## CONSTRUCTION DOCUMENTS REVIEW

RE: QUIZNOS SUB  
East Judge Perez, Store #7452  
2022 E. Judge Perez  
Chalmette, LA 70043

7452

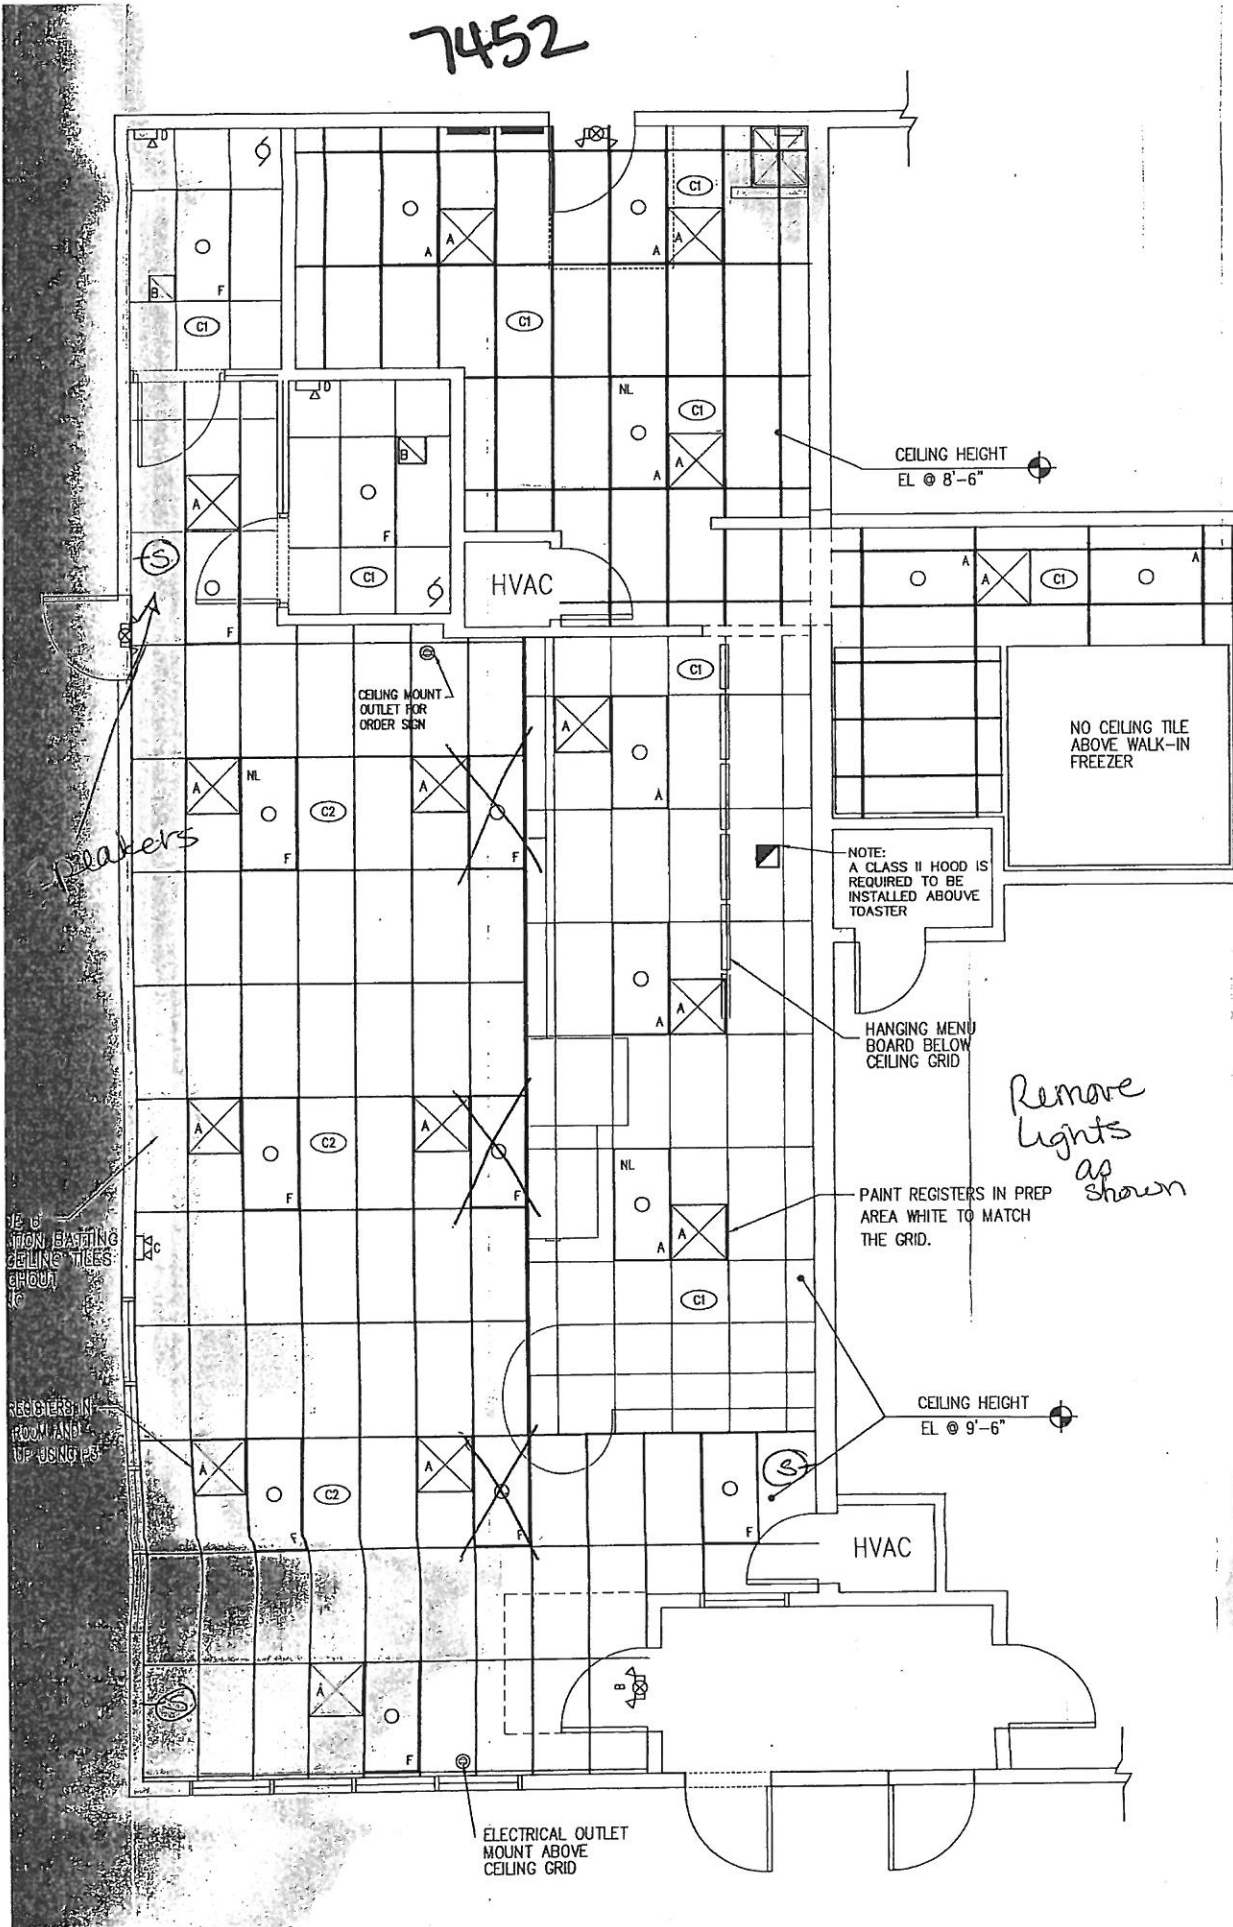
- c. **Refer to prototype for correct wall covering placement.** "V4" to be place behind the "Toasty" poster (if applicable). Do not place wall covering of the same color side by side, alternate colors (V2, V3, V4 etc.). See attached.

Extend river

7452

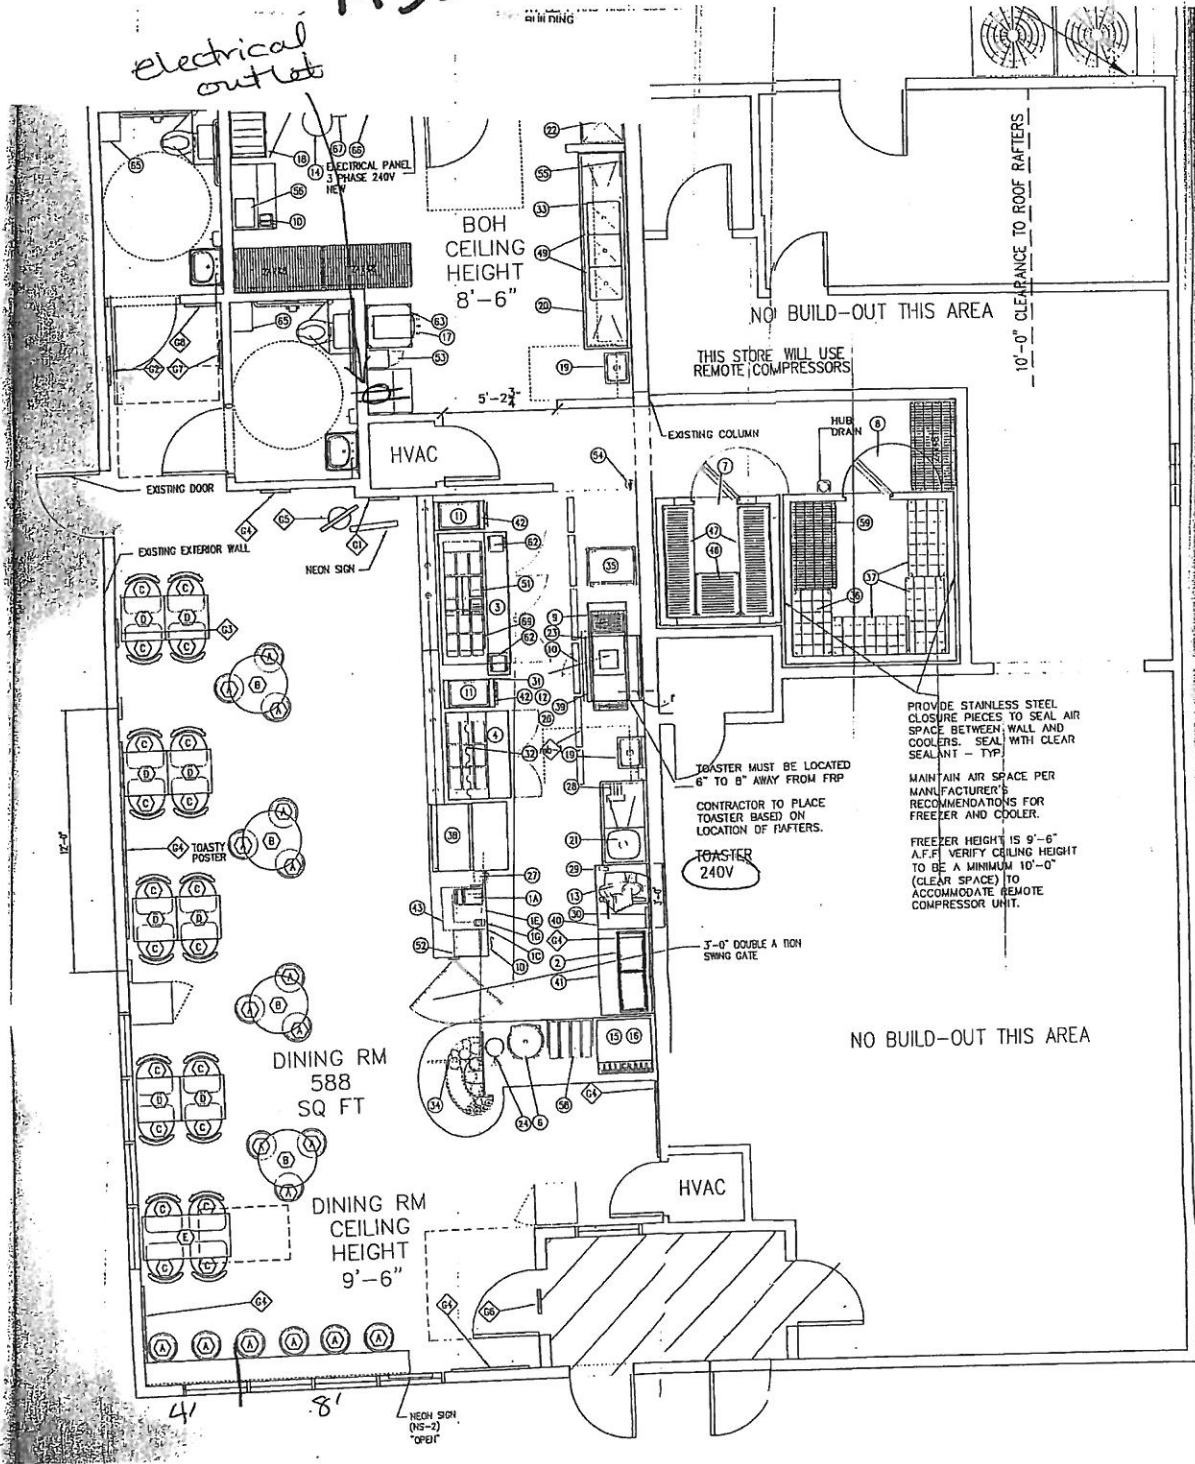
electrical outlet
